SUBJECT: Preliminary Grading: Reserve at River Oaks

PC Case No: 2016-17

MEMORANDUM

Re: **Future Pond No. 5 (River Oaks Phase 2) Plan Review**

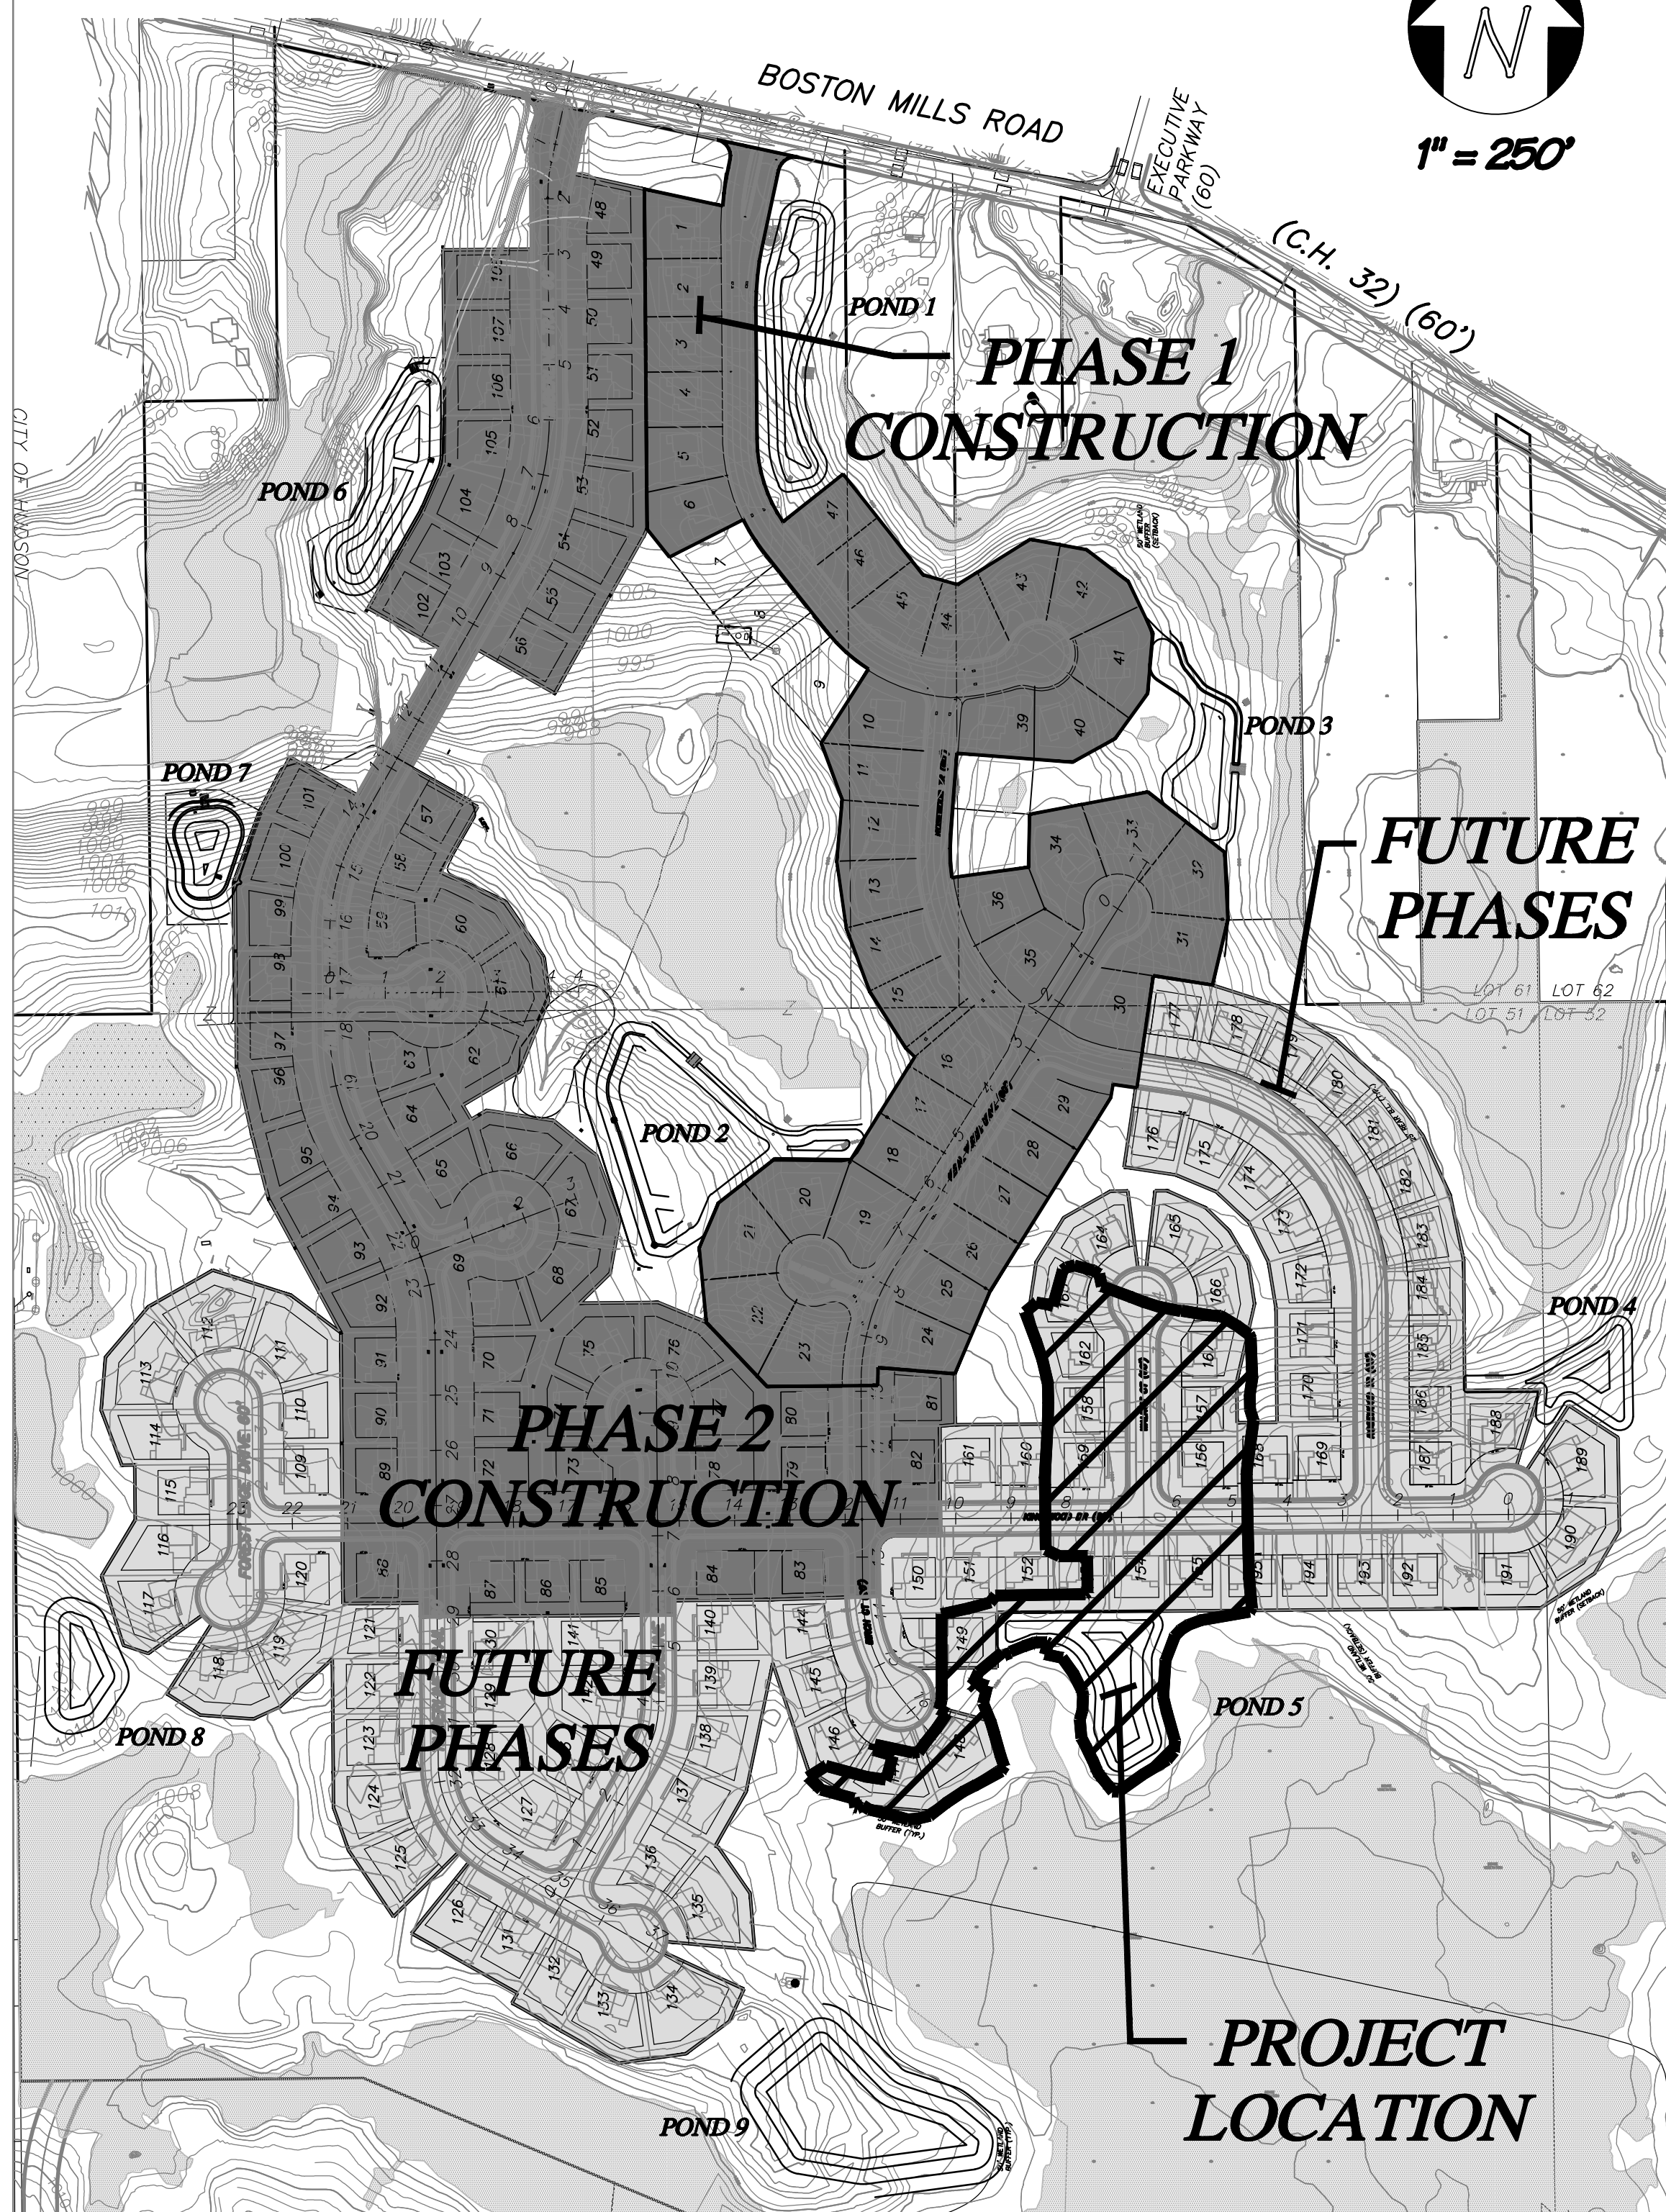
Please see the redlined comments on the existing set of plans attached to this letter. Please return the redlined plans with the next submittal. The following review comments shall be addressed and all applicable items shall be resubmitted to the City of Hudson:

S.W.P.P. DETAILS & LEGENDS - FUTURE POND NO. 5 THE RESERVE AT RIVER OAKS - PHASE 2 CITY OF HUDSON SUMMIT COUNTY, OHIO

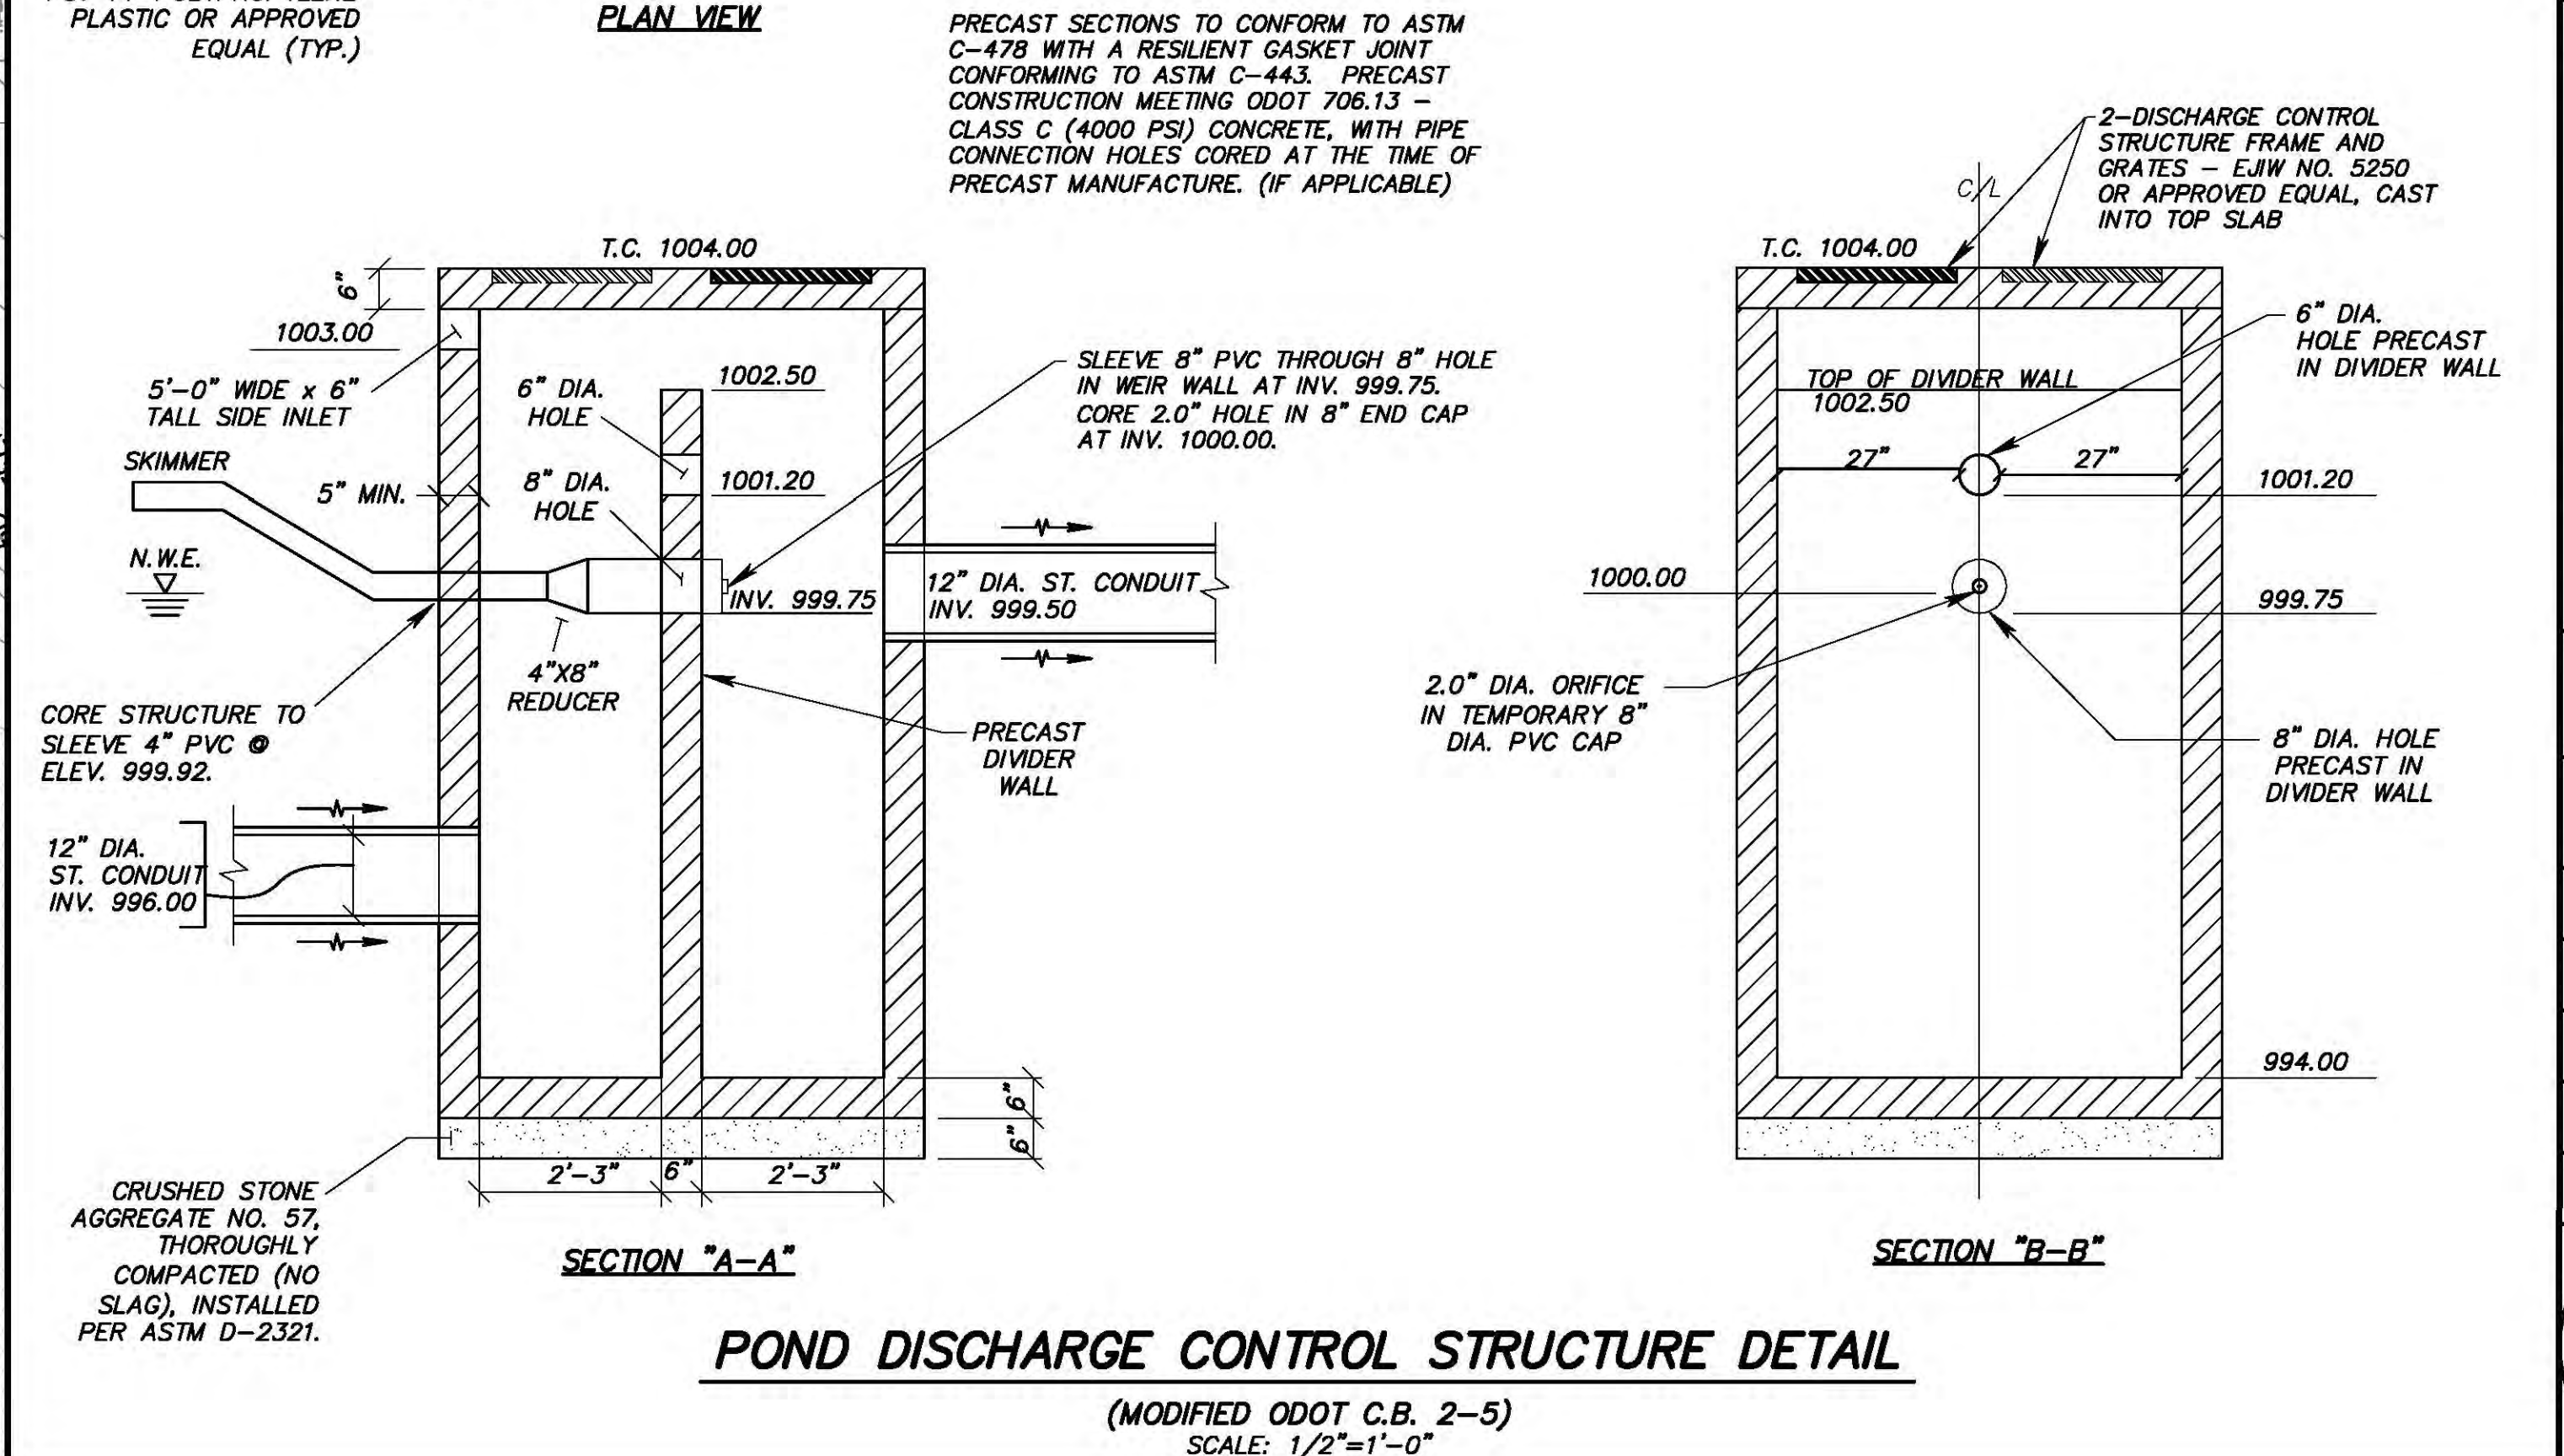
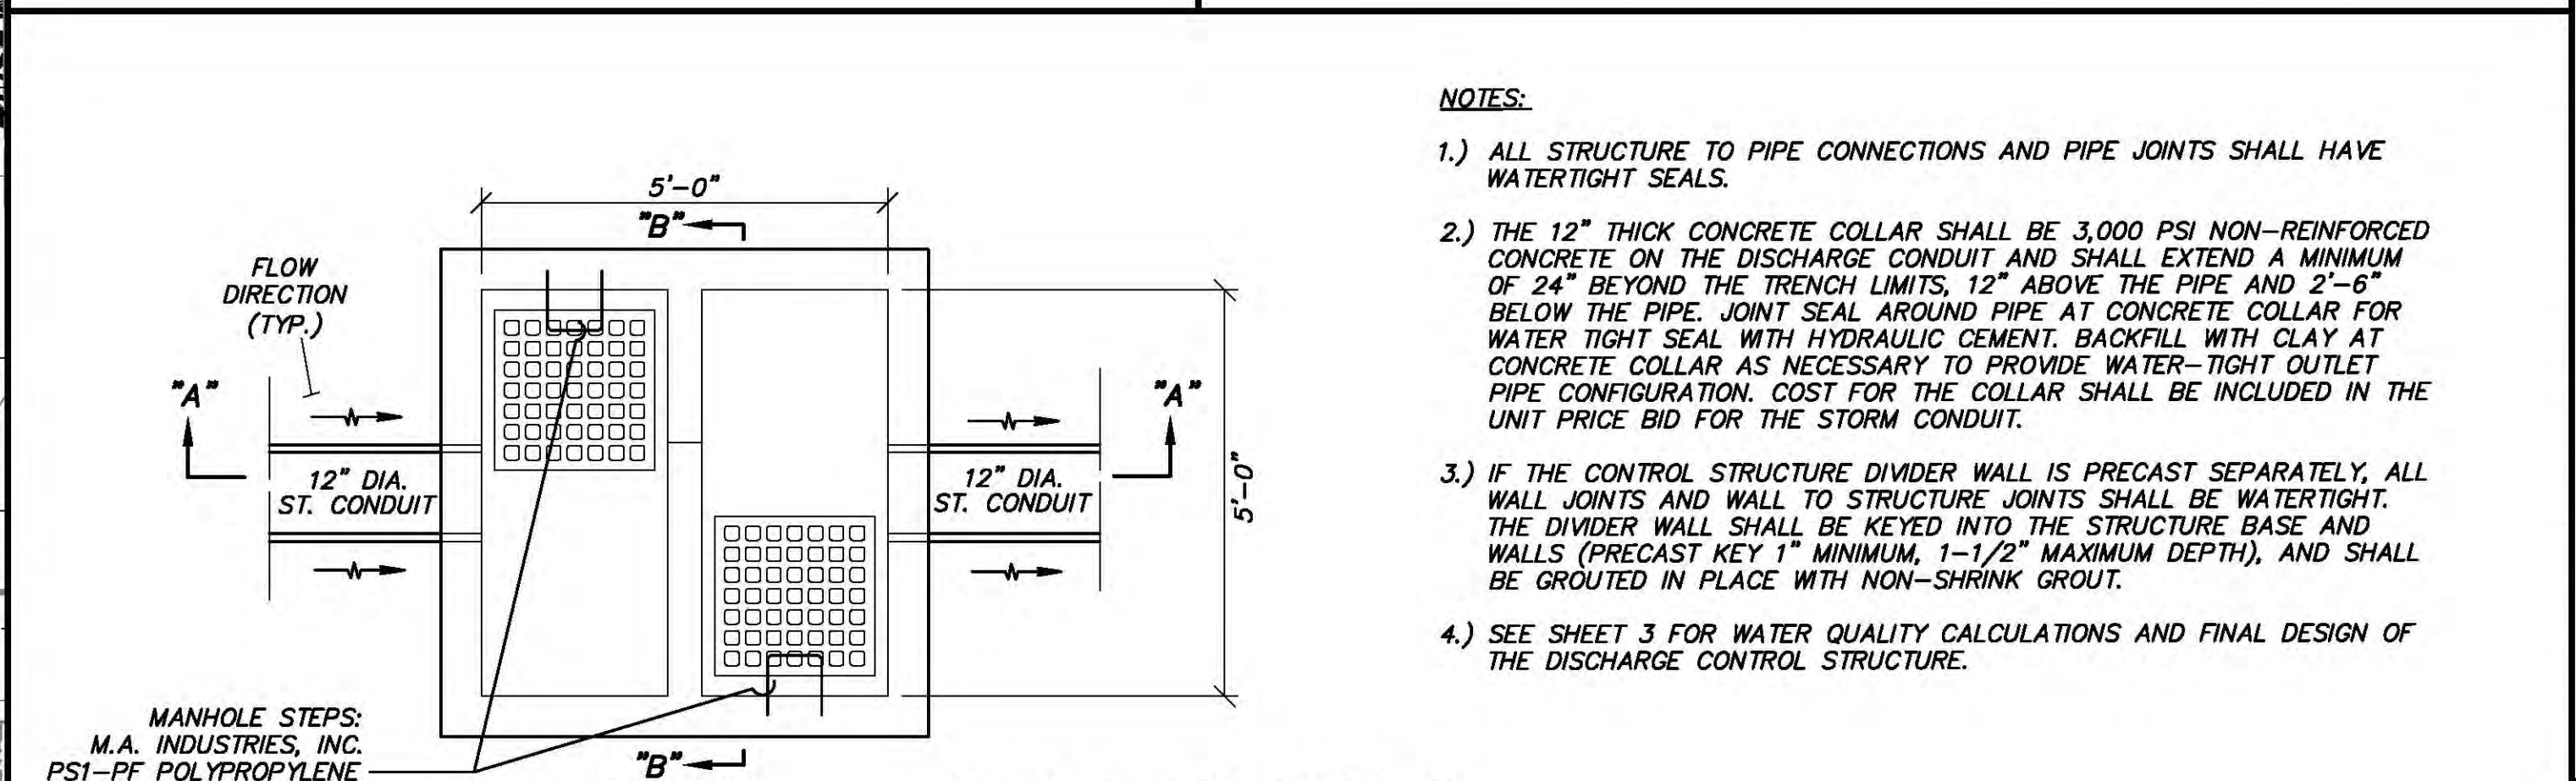
4. Provide approval letter from Summit Soil and Water Conservation District.
5. The plan shows three sets of contours; grey scale (existing), thin bold (future) and thick bold. Please label contour styles or revise drawing to clarify what is being represented.

6. Provide labeling as marked on plan.
